June 17, 2026

Re: 210 – 222 College Avenue East – Transportation Impact Study Update & Response to Comments (File No. OZS26-003)

Transportation-related City of Guelph staff comments have been provided within two memoranda prepared by City's Development Planning Department, dated May 2026, and from the Engineering and Transportation Services Department, dated April 29, 2026. These comments are addressed herein, and responses have been organized by comment with a summary discussion which refers, as appropriate, to technical materials provided within this letter. Staff comments are provided in **Appendix B** for reference.

Exhibit 4: Proposed Site Driveway Location Looking Right (West)

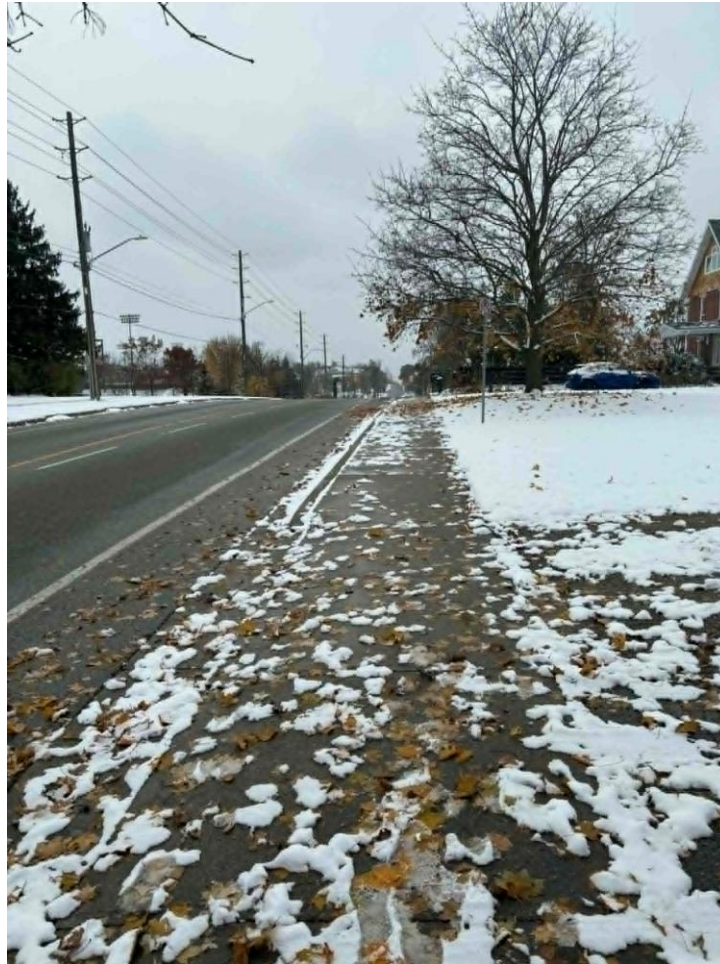
Please provide a sightline assessment at the proposed site access, as visibility may be limited due to the crest along College Ave. Please confirm that adequate sight distance is provided in accordance with TAC guidelines. In addition, the current access geometry appears to extend beyond the easterly property line. Please revise the access design to ensure it is fully contained within the subject property and complies with City standards. Consider relocating the driveway to the west limit of the property to improve sightlines and shorten the walking distance for pedestrians to reach the existing signalized intersection at East Ring Road and College Avenue.

The site visit conducted in November 2025 identified a potential sight line deficiency for left turning vehicles exiting the proposed Site driveway due to a crest curve that exists on College Avenue East as the road continues west towards East Ring Road. **Exhibit 4** illustrates this condition.

SITE PLAN Project

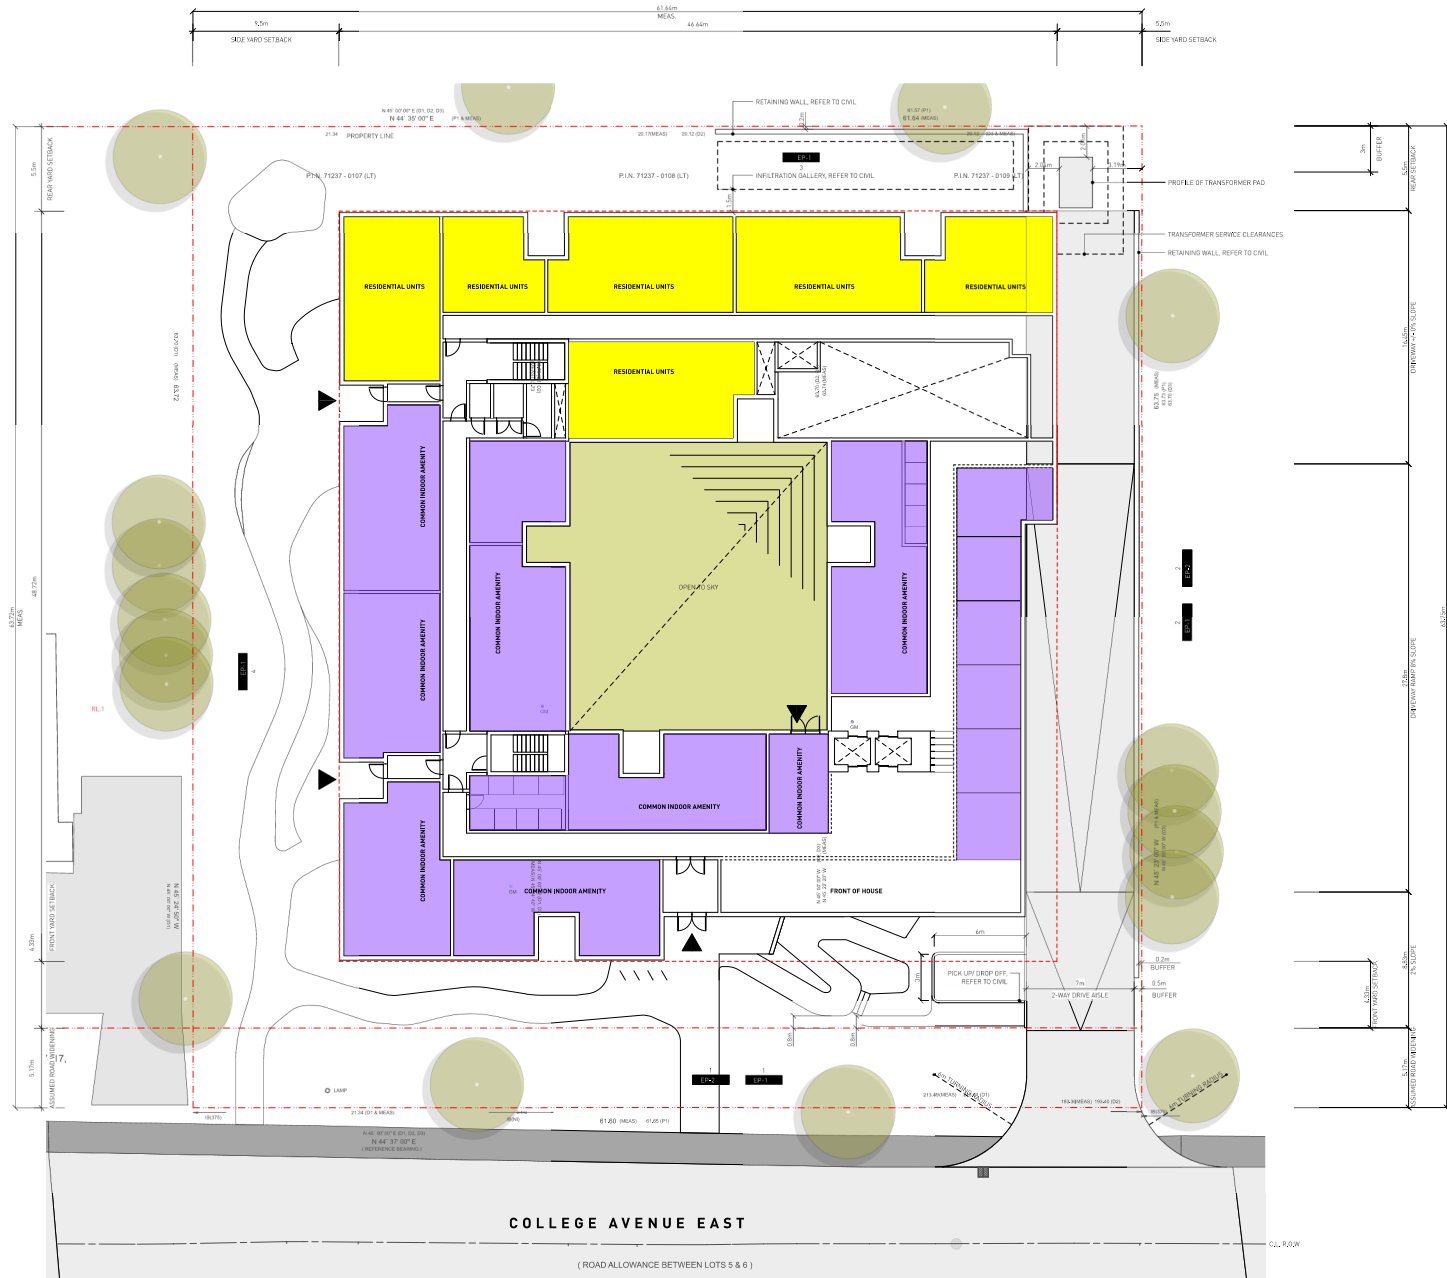
Drawing SP-1: Please revise the proposed driveway width to 7.5 m with a 7.0 m curb radius, in accordance with Table 6-2 of the City's Development Engineering Manual.

PARKING LEVEL FLOOR PLAN (LOW) Project: 0827
Sheet

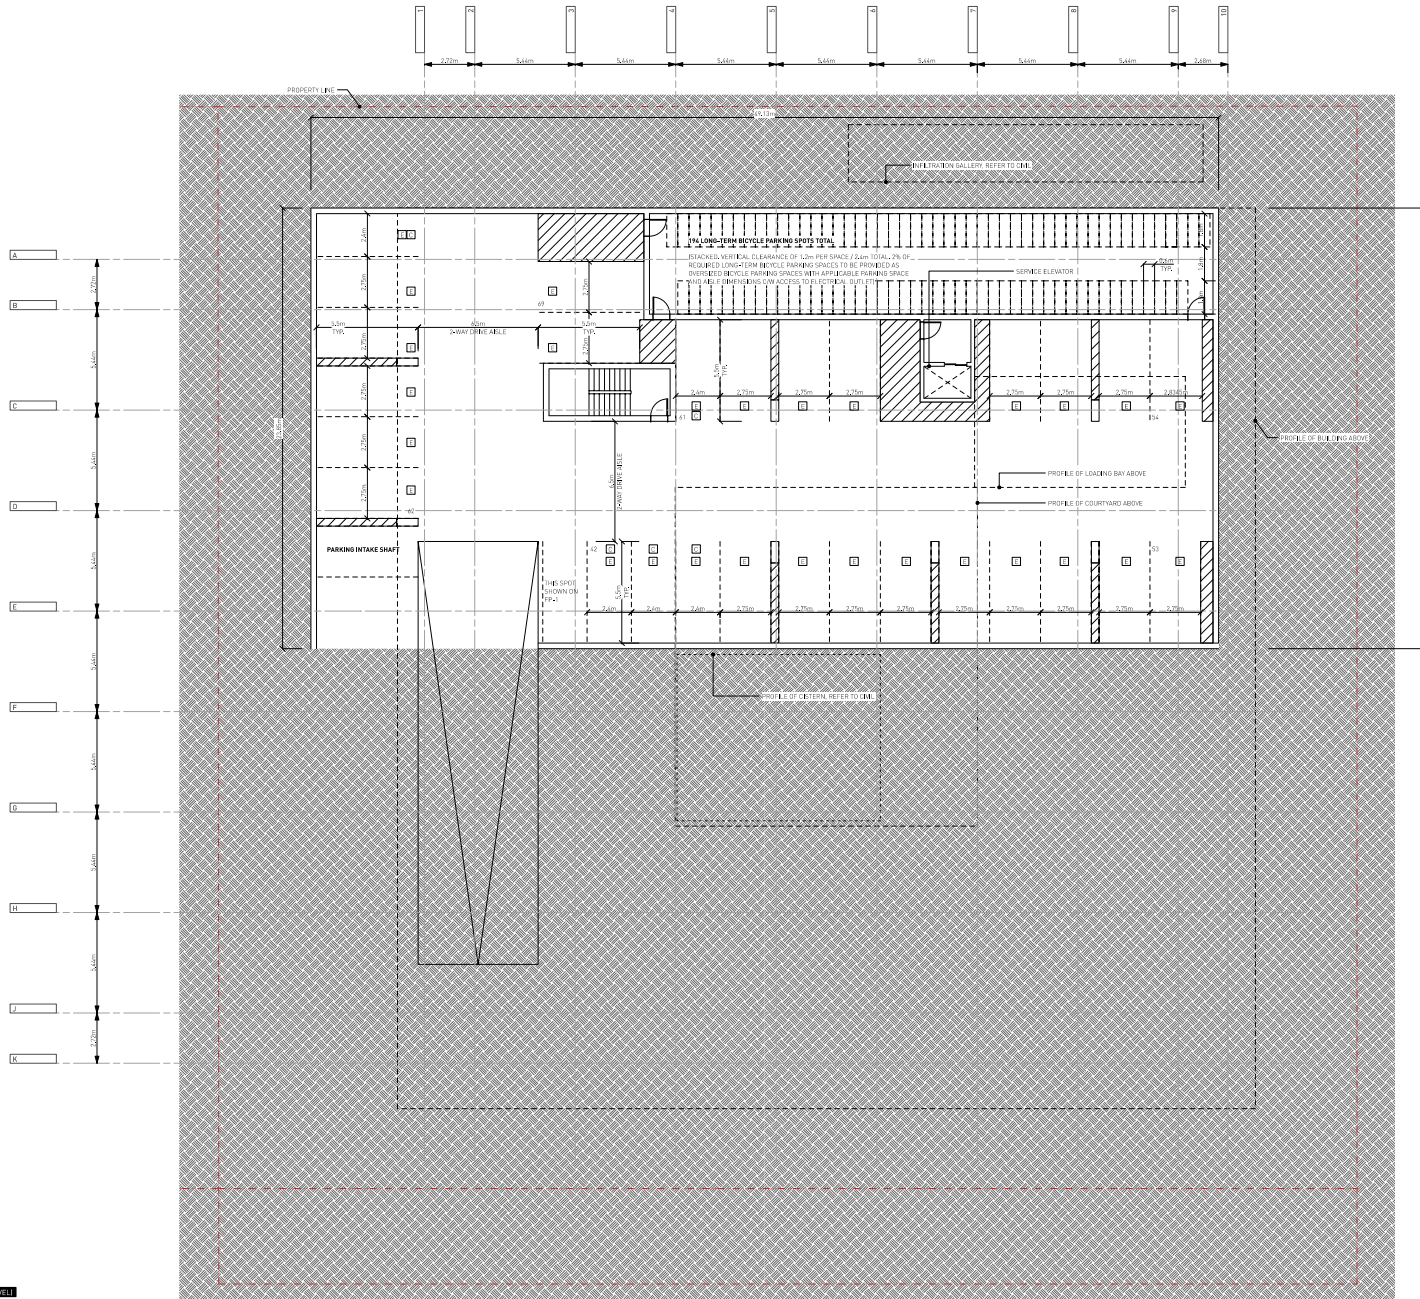
Alternative to the suggestion provided by Transportation staff, to promote cycling and support safe and convenient bicycle connections from the municipal right-of-way to the site, Planning staff recommend the applicant locate the long-term bicycle parking on the first storey of the building rather than on the P2 level, and provide a direct from the long-term bicycle parking area to the municipal right-of-way that is separate from the vehicle access driveway and won't require cyclists to travel through the loading bay.

2. **Drawing FP-1 and FP-2:** Please provide a hammerhead for the end parking spaces with dimensions. A minimum 1.2 m hammerhead depth is required.
3. **Drawing FP-2:** Please revise the long-term bicycle parking layout to improve access and functionality. The current access from the service elevator is indirect, and the door located at the end of parking stall #51 is not optimal. Consider providing a more direct point adjacent to the west side of the elevator. Please also provide a balanced mix of parking options (e.g.,

As noted in **Section 2.5**, additional long-term bicycle parking spaces are provided above Zoning By-law (2023)-20790 minimum requirements to leverage the Site's strong cycling connections and encourage alternative travel modes to / from the Site. The bicycle parking supply in the revised proposal remains on the P2 level, which is effectively one level below grade due to the natural grading of the Site. It is our opinion that the proposed location of the long-term bicycle parking is appropriate and accessible; however, BA Group will continue to review the proposed bicycle parking arrangements as part of the Site Plan Approval process.

Appendix C: Pick-Up / Drop-Off Accommodation Plan

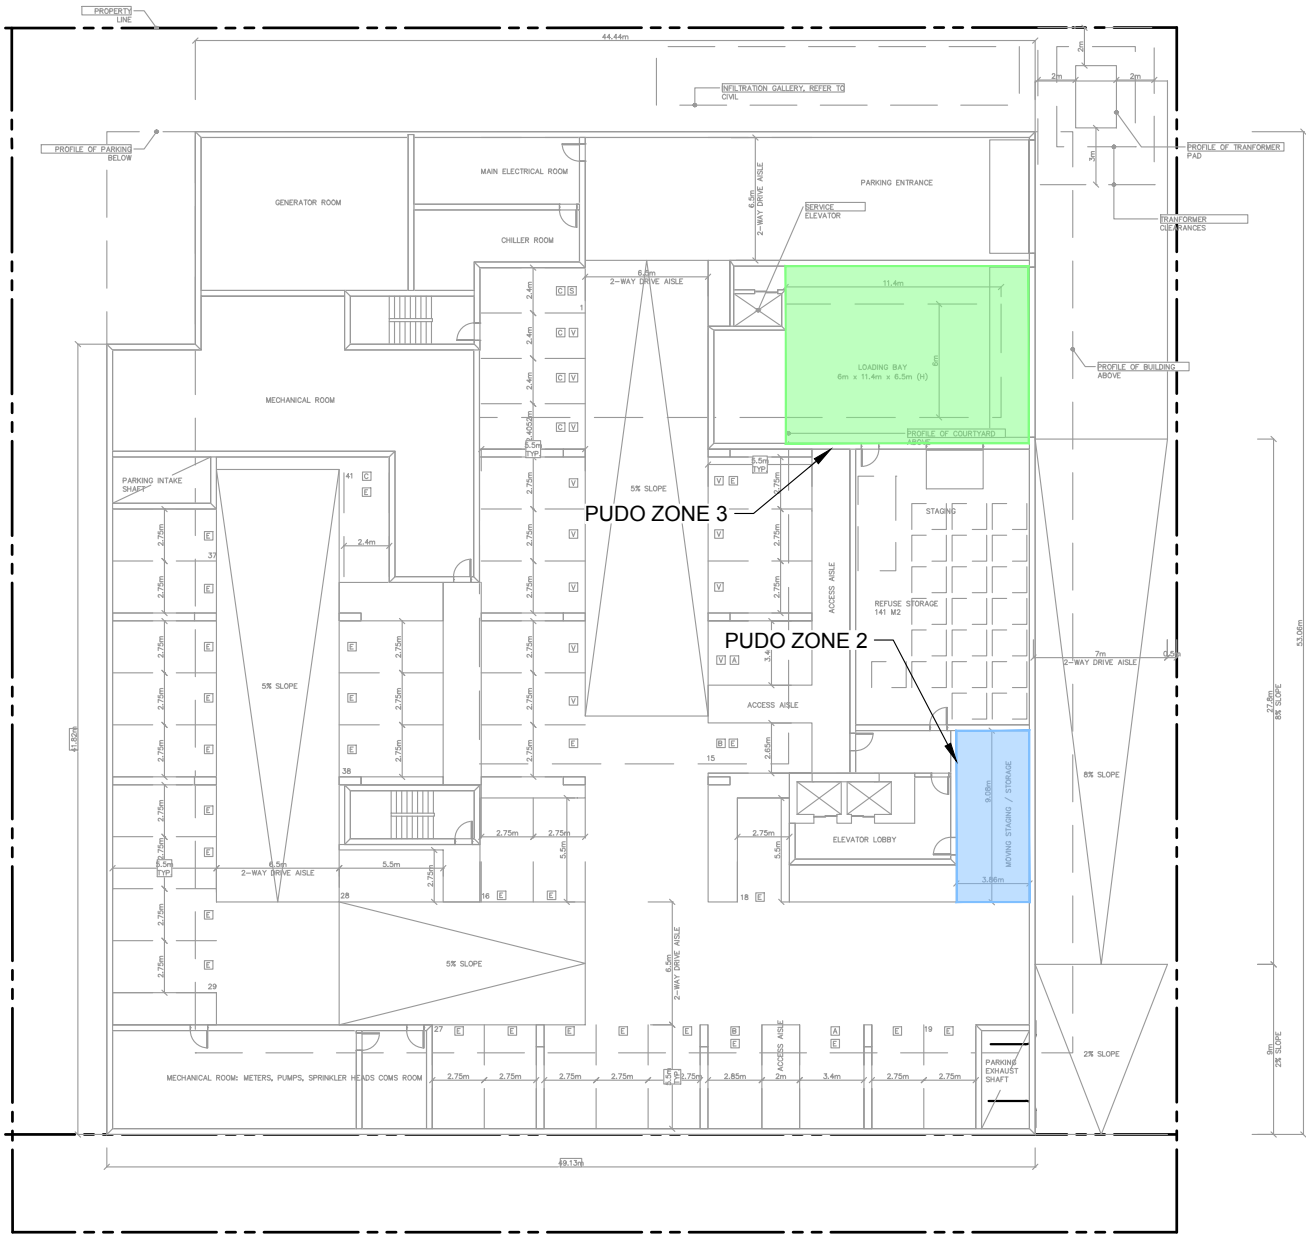
A pick-up/ drop-off (PUDO) area is shown near the building entrance and appears to be intended for passenger pick-up and drop-off. Please review the location and operation of this space, as its proximity to the site access may create conflicts with entering and exiting vehicles and impact on internal circulation. Given the scale of the development, please clarify how pick-up/drop-off and short-term delivery activities (e.g., food delivery and parcel services) will be accommodated on site.

A pavement marking and signage plan will be provided at the Site Plan Application stage of the development that will indicate where specific on-Site activities are intended to occur and recommend corresponding control measures, as necessary.

As noted in **Section 5.0**, the pick-up / drop-off facilities can continue to be refined during the Site Plan Approvals stage of the project.

Based on the above, it is our opinion that the proposed pick-up / drop-off facilities (5 spaces) can accommodate the Site's short-term vehicle activities, and that the design / location of the proposed facilities is appropriate. Further coordination with City staff related to the pick-up / drop-off facilities and related way-finding signage will be provided during the Site Plan Approval stage of the development.
